Comments on the North One Hotel Development and Apartments: - as detailed in the Referral Report to NT EPA by BPL Environmental, dated September 2021

Submitted by: Mike Nicholls, Rapid Creek, 2 Nov 2021

Fig. 4 From the 2500 Topo Cadastre plan from NT Atlas. For scale, the vertical grid lines are 100 m apart. The southern boundary of the “Escarpment” is the thick blue line except:
1) The triangular area on NE side of Lot 2422 is also within the Escarpment - and,

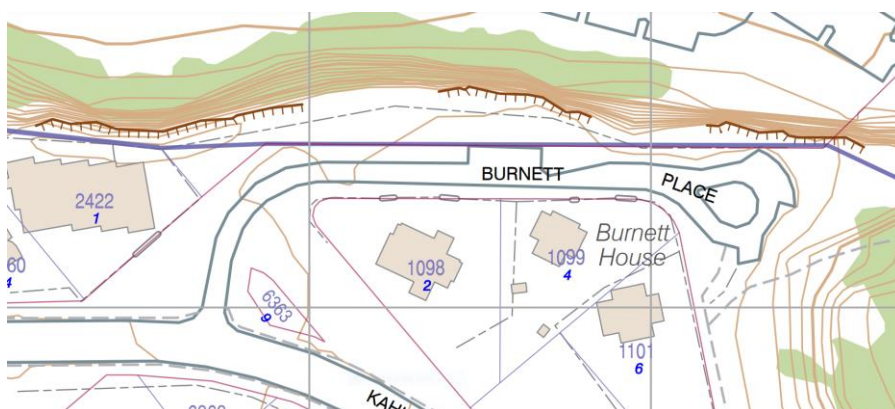
2) The Escarpment boundary heads NE from the point I will call “Y” near the right end of the drawing instead of following the blue line to the SE. (The blue line actually marks the boundary between the suburbs of Larrakeyah and The Gardens.) The existing fence near the top of the physical escarpment is shown by the dashed black line. Note that the fence and the Escarpment boundary are coincident for about 50 m west from point Y. The strange, straight, southern boundary to Lot 7651 must date back to the days of lazy surveyors – the boundary should be the fence line – just as shown in the 2014 Concept Plan below.

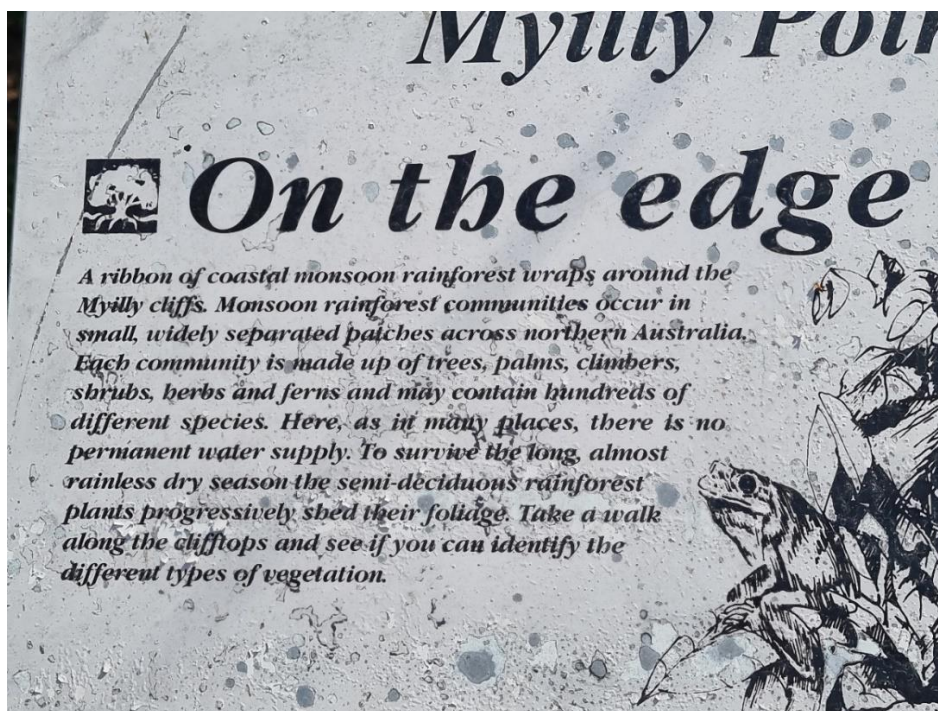
Fig. B9 Note the sentences: “Here, as in many places, there is no permanent water supply. To survive the long, almost rainless dry season the semi-deciduous rainforest plants progressively shed their foliage.” MN: It is apparent that these days, during the dry, much of the escarpment further west receives ground water from garden sprinkler irrigation, or leaking pipes, on the plateau above.

Fig. B 13 New rock revetment and foreshore path looking south toward Nurses Walk. The path appears to be at about 4.0 m AHD. (*This is an important level to remember when reading Appendix D.*)

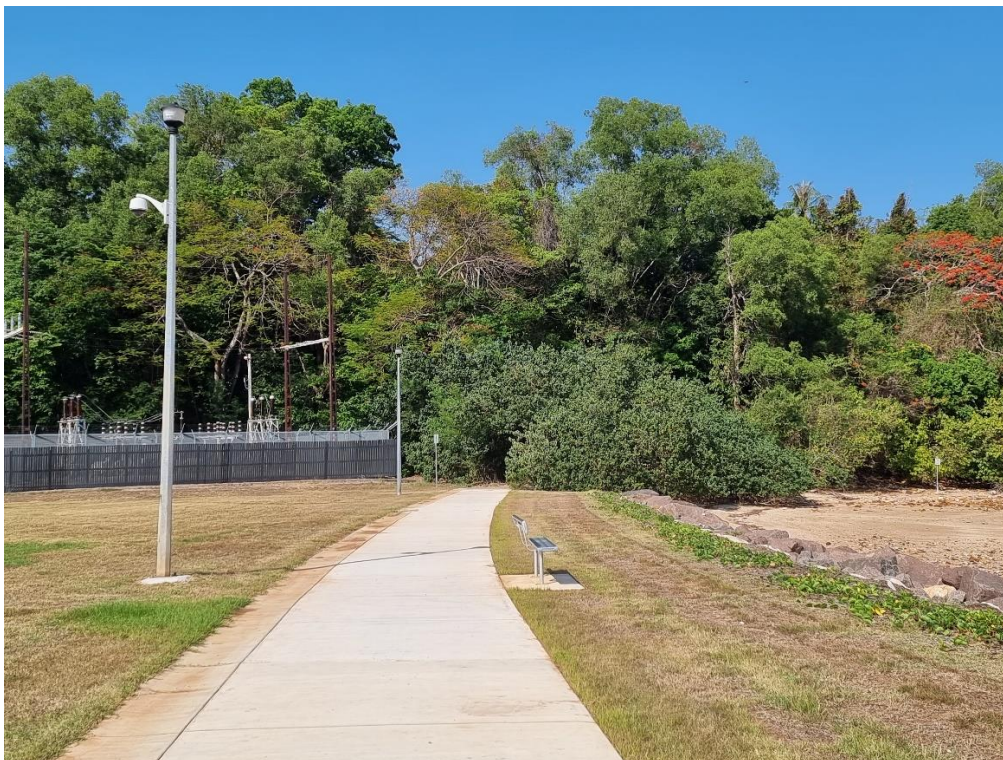
Questions: Is the western boundary of Lot 7651 to the east of the nearest light pole.? If so, how far east ?
